CSNHS-M002-00(965)
Pavement Rehabilitation for
Interstate I-20 from the Georgia-Alabama
State Line to S.R. 61

Value Engineering Study Report

Concept Design Stage

March 2005

SHEET NO.: 4 of 5

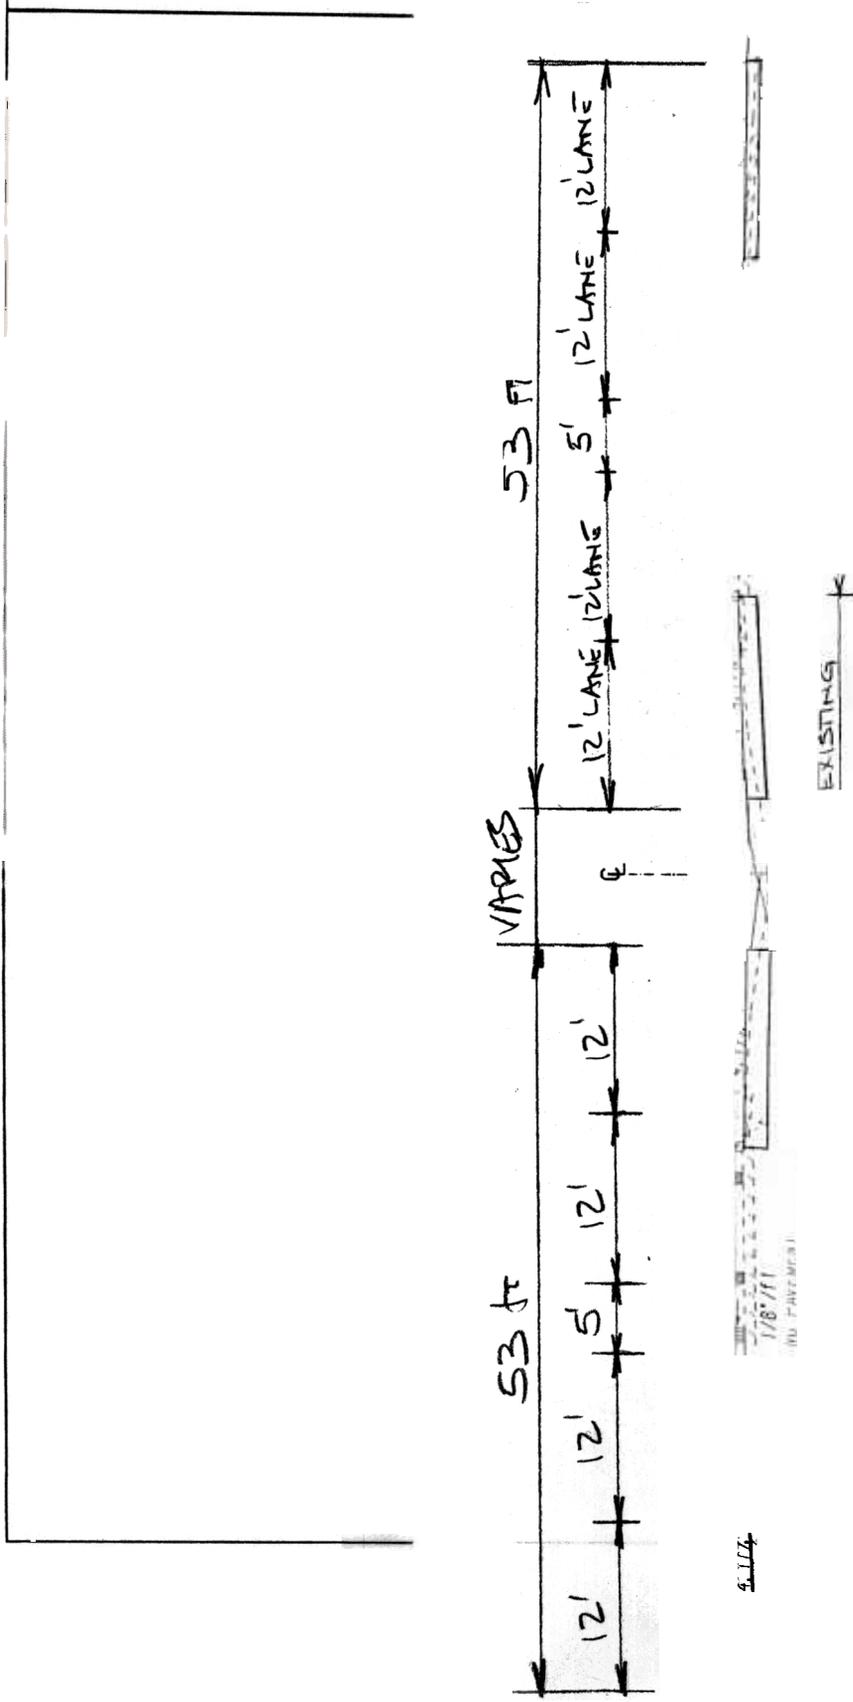
DESCRIPTION: **STAGE ALL TRAFFIC TO ONE SIDE**

The original design proposed staging with contra-flow and split traffic with off-peak lane closings.

Shift all traffic to one roadway.

Stage 1 – Construct outside shoulder improvements – 14 ft. wide – full-depth pavement with associated earthwork and grading/safety improvements.

Construct inside shoulder improvements 15 ft. wide – full depth pavement with associated earthwork and grading/safety improvements.

This construction yields a 55 ft.-wide full-depth roadway area suitable for 4 through lanes with a concrete barrier. Additional pull-off/emergency break down areas should also be constructed

ORIGINAL DESIGN TYPICAL SECTION

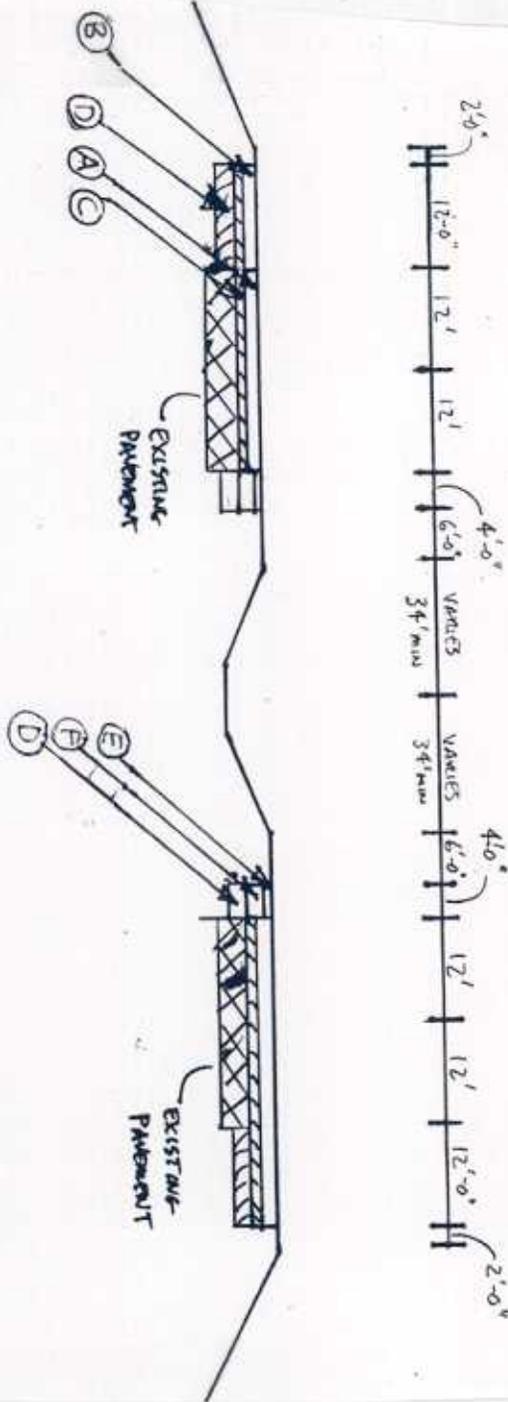
The original design calls for the overlay of the existing concrete pavement section with continuous reinforced concrete, and the replacement of the paved concrete outside shoulders with full-depth concrete shoulder pavement. Sketches shown are typical sections.

The original design calls for the overlay of the existing pavement with an 11" continuous reinforced concrete overlay and a 330#/sy 19mm asphalt layer. The proposed alternative calls for a full depth replacement with an 11" continuous reinforced concrete layer, a 330#/sy 19mm asphalt layer and a 12" layer of GAB. The original design, since it will overlay the existing pavement by 14" will raise the profile grade line and will create substandard clearances at bridge overpasses. Therefore the original design will require jacking the existing bridges to establish acceptable clearances. The proposed alternative, since it will remove and replace the existing pavement at the existing profile grade line, will allow the clearances at bridge overpasses to remain as they exist and will not require jacking the bridges.

PROPOSED ALTERNATIVE TYPICAL SECTION

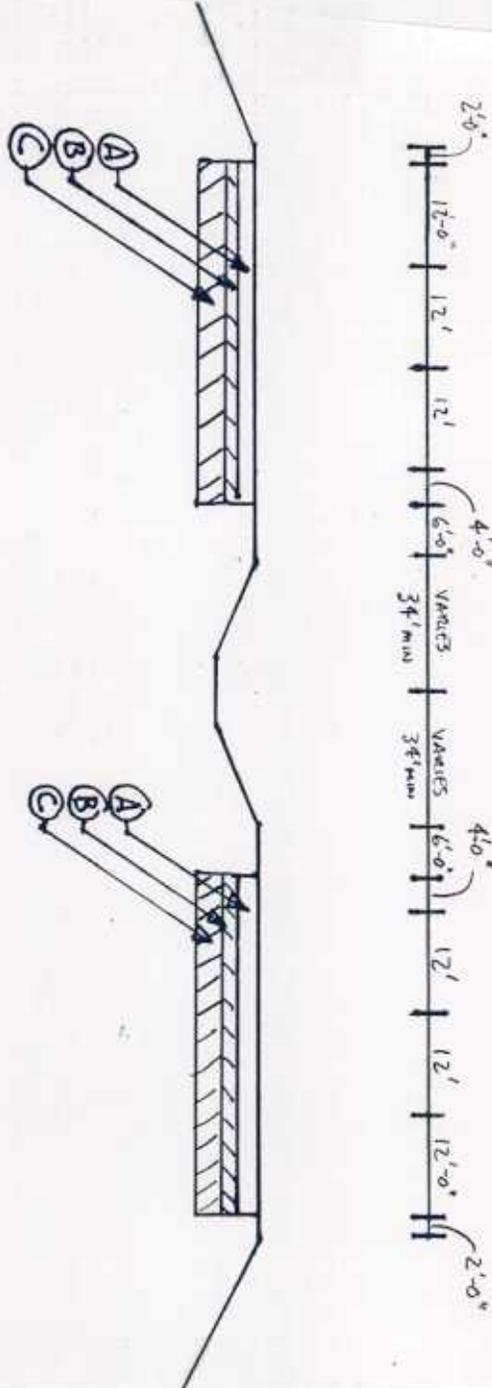
The alternative sign calls for the removal of the entire pavement section, and replacement with full-depth continuous reinforced concrete, including full-depth concrete shoulder pavement. Sketches shown are typical sections.

SHEET NO.: 6 of 16

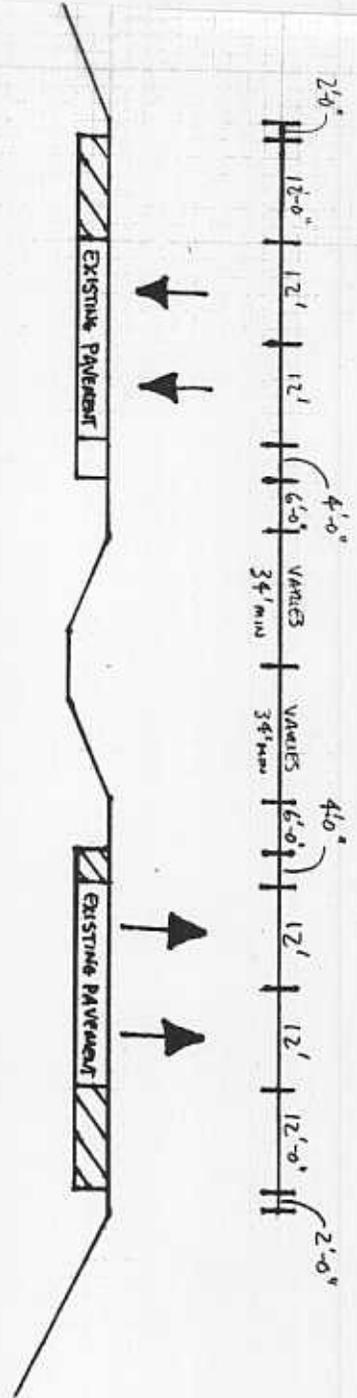
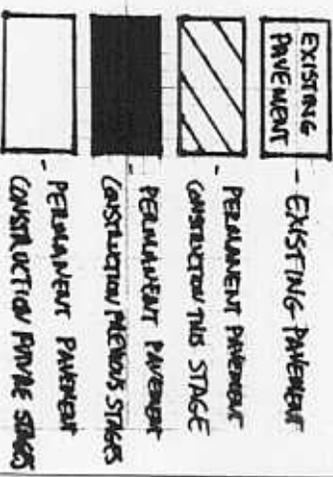
- MAINTAIN TRAFFIC IN CURRENT LANE CONFIGURATION
- CONSTRUCT PERMANENT FULL DEPTH 12' SHOULDER PAVEMENT IN EASTBOUND AND WESTBOUND DIRECTIONS
- CONSTRUCT PERMANENT FULL DEPTH 4' SHOULDER PAVEMENT IN EASTBOUND DIRECTION

SHEET NO.: 7 of 16

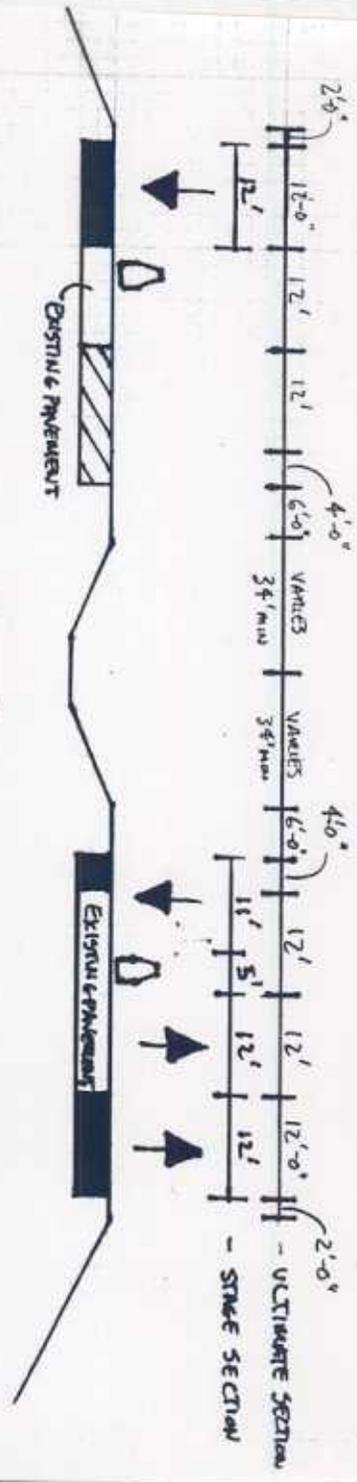
- INSTALL BARRIERS AND SHIFT TRAFFIC
- SHIFT EASTBOUND TRAFFIC TO OUTSIDE EASTBOUND LANE AND 12' SHOULDER PAVEMENT
- SHIFT INSIDE LANE OF WESTBOUND TRAFFIC TO INSIDE EASTBOUND LANE AND SHOULDER PAVEMENT
- SHIFT OUTSIDE LANE OF WESTBOUND TRAFFIC TO 12' SHOULDER PAVEMENT
- CONSTRUCT PERMANENT FULL DEPTH 12' INSIDE LANE IN WEST BOUND DIRECTION
- CONSTRUCT PERMANENT FULL DEPTH 4' SHOULDER PAVEMENT IN WESTBOUND DIRECTION

SHEET NO.: 8 of 16

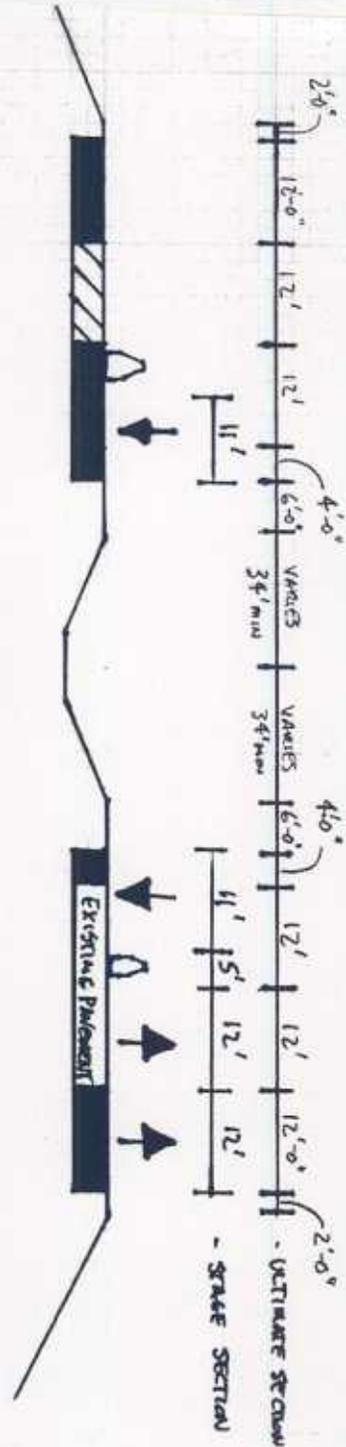
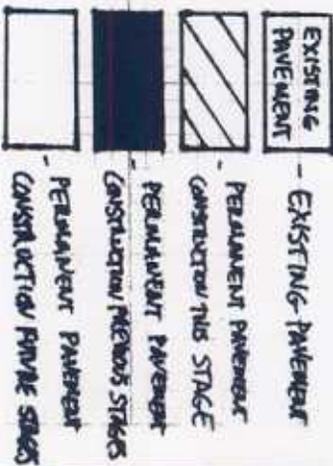
- INSTALL BARRIERS AND SHIFT TRAFFIC
- EAST BOUND AND INSIDE WESTBOUND TRAFFIC TO REMAIN AS SHOWN IN STAGE II
- OUTSIDE WESTBOUND LANE TO BE SHIFTED TO INSIDE WESTBOUND LANE AND SHOULDER REMOVED
- CONSTRUCT REMAINING FULL DEPTH 12' OUTSIDE LANE IN WESTBOUND DIRECTION

SHEET NO.: 9 of 16

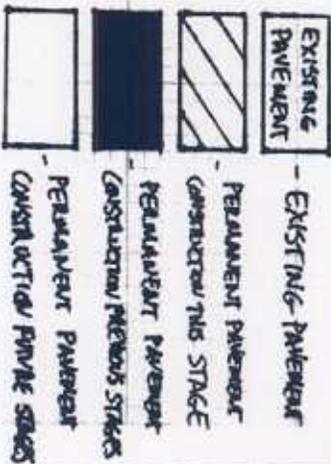
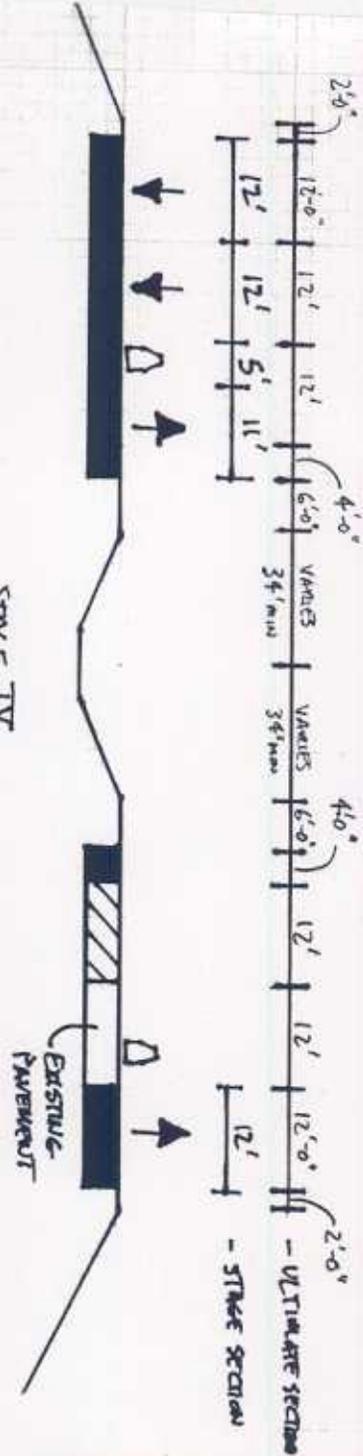
- IN STILL BARRELS AND SHIFT TRAFFIC
- SHIFT WESTBOUND TRAFFIC TO OUTSIDE WESTBOUND LANE AND 12' SHOULDER PAVEMENT
- SHIFT INSIDE LANE OF EAST BOUND TRAFFIC TO INSIDE WESTBOUND LANE AND 4' SHOULDER PAVEMENT
- SHIFT OUTSIDE LANE OF EAST BOUND TRAFFIC TO 12' SHOULDER PAVEMENT
- CONSTRUCT PERMANENT BUT FULL DEPTH 12' INSIDE LANE IN EAST BOUND DIRECTION

SHEET NO.: 10 of 16

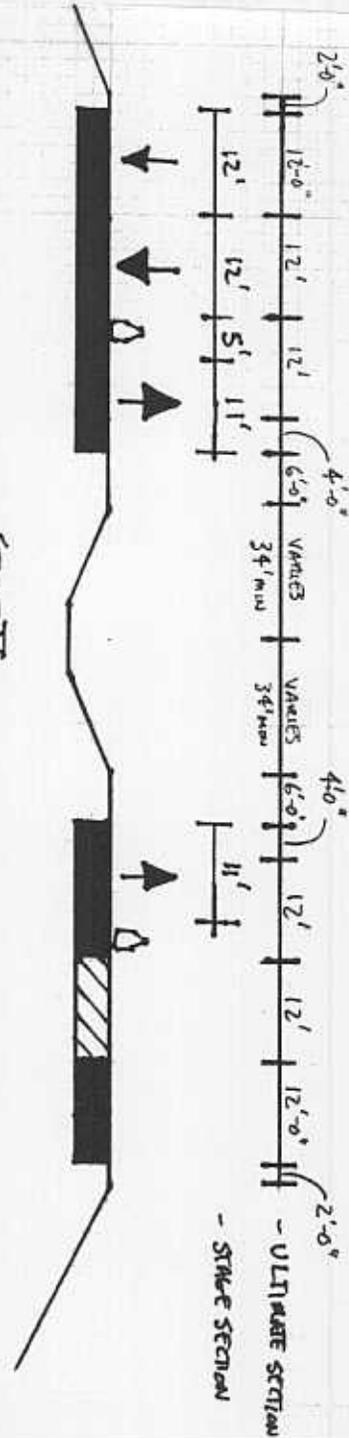
- INSTALL BARRIERS AND STOP TRAFFIC
- RESTROOMS AND INSIDE EASTBOUND TRAFFIC TO REMAIN AS SHOWN IN STAGE IV
- OUTSIDE EASTBOUND LANE TO BE SHIFTED TO INSIDE EASTBOUND LANE AND SHOULDER PAVED
- CONSTRUCT PERMANENT FULL DEPTH 12' INSIDE LANE IN EASTBOUND DIRECTION.

SHEET NO.: 11 of 16

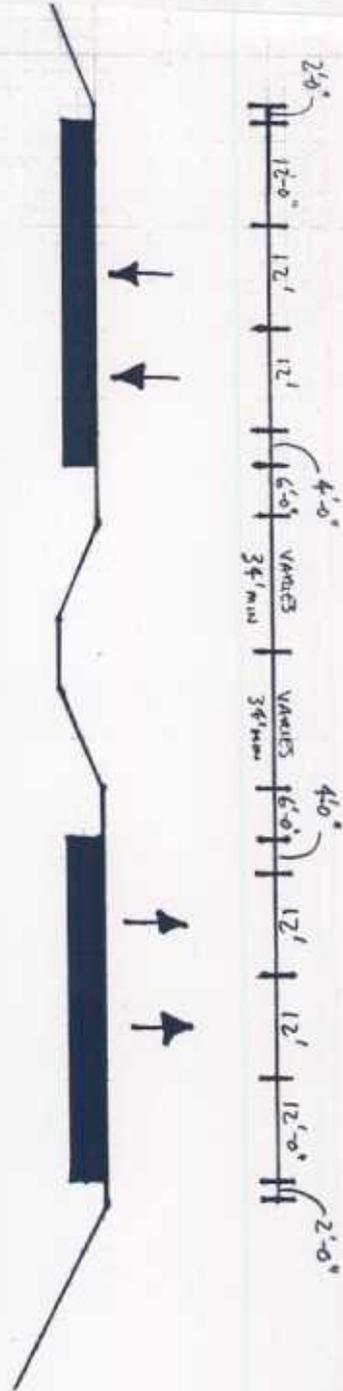
• REMOVE BARRIERS AND SHIFT TRAFFIC TO NORMAL CONDITIONS

PROPOSED ALTERNATIVE TYPICAL SECTION

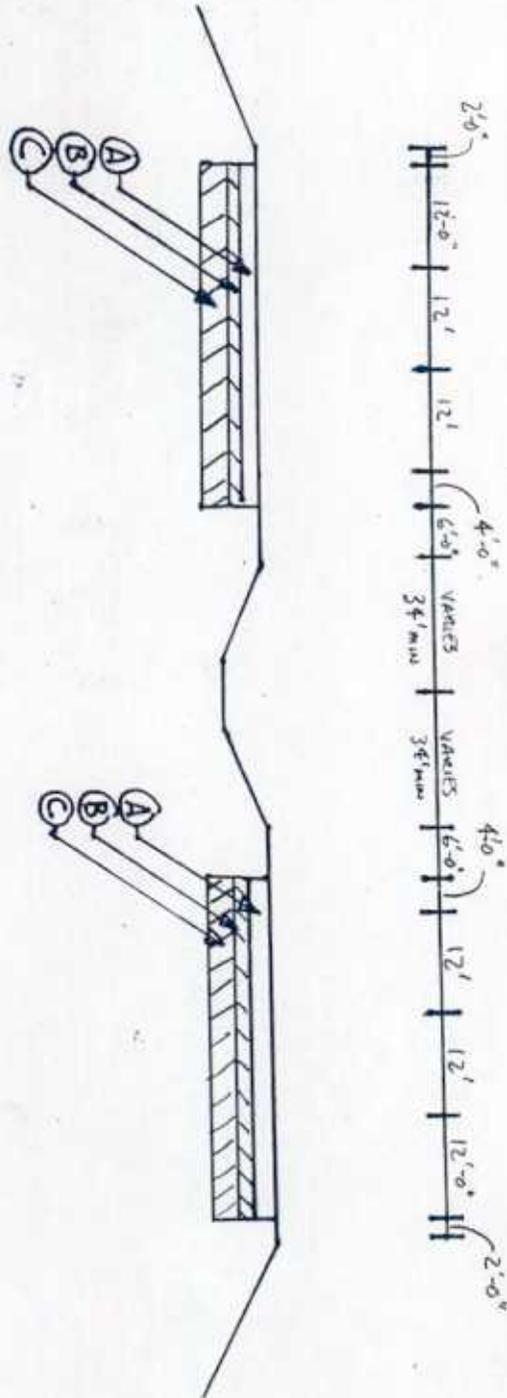
The original design overlays the entire project except for full-depth replacement for the beginning and ending 3 miles (total of 6 miles). Existing crossover bridges must be jacked to accommodate the vertical clearance reduction due to the overlay.

The alternative uses full-depth replacement (FDR) of the pavement in the interchange areas in addition to the beginning and ending locations that are to be full-depth replaced in the original design.

Replacing the pavement at the same elevation would remove the requirement to jack the existing concrete bridges while maintaining the existing vertical clearances.

SHEET NO.: 2 of 15

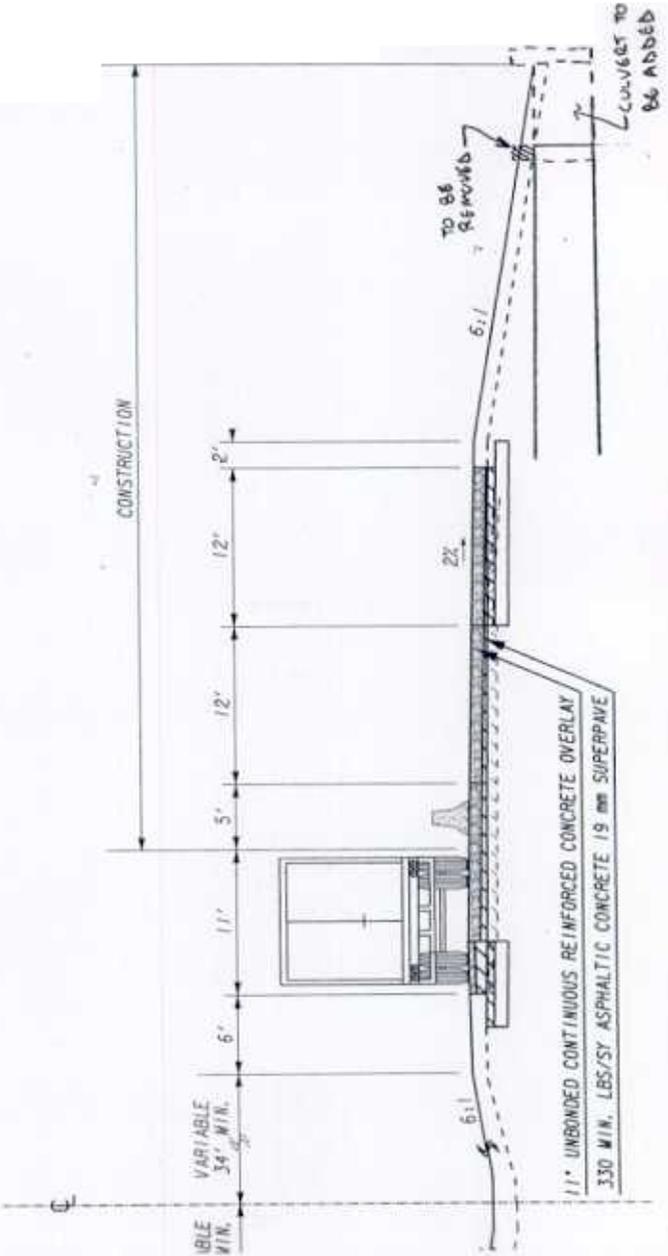
The original design will add additional fill to the cross section and cause the side slopes to extend such that nine existing bridge culverts and five existing box culverts might need to be extended.

Alternate design would use “barn roof” side slopes to tie fills in quicker (beyond the clear zone).

SHEET NO.: 2 of 4

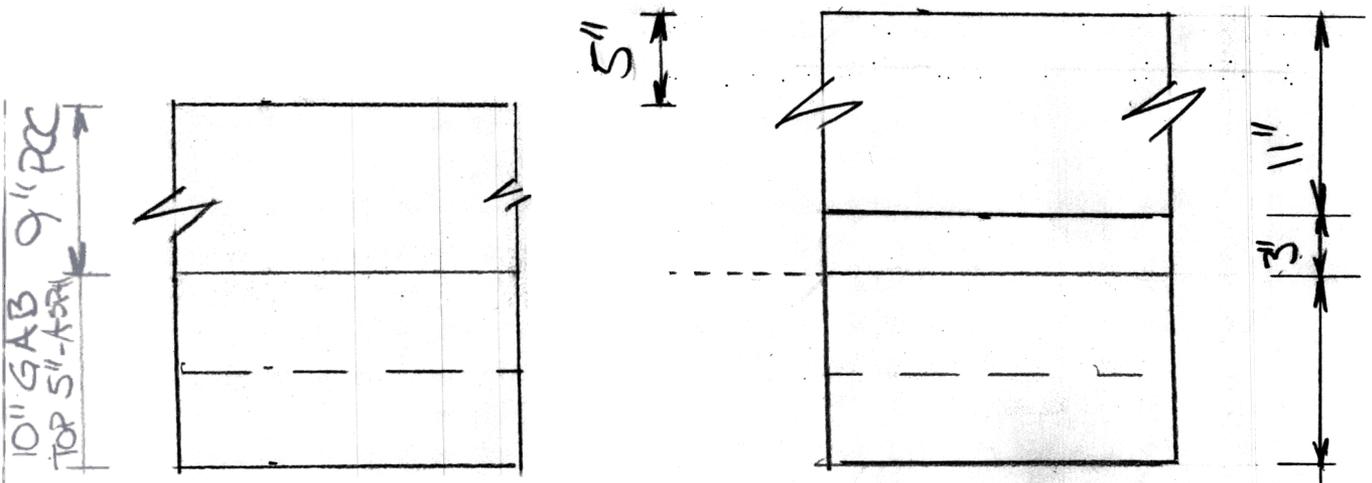
Use a modified pavement section within “non-problem” areas between the two three-mile sections at either end where the pavement is at its worst.

SALVAGE & REUSE EXISTING
BASE
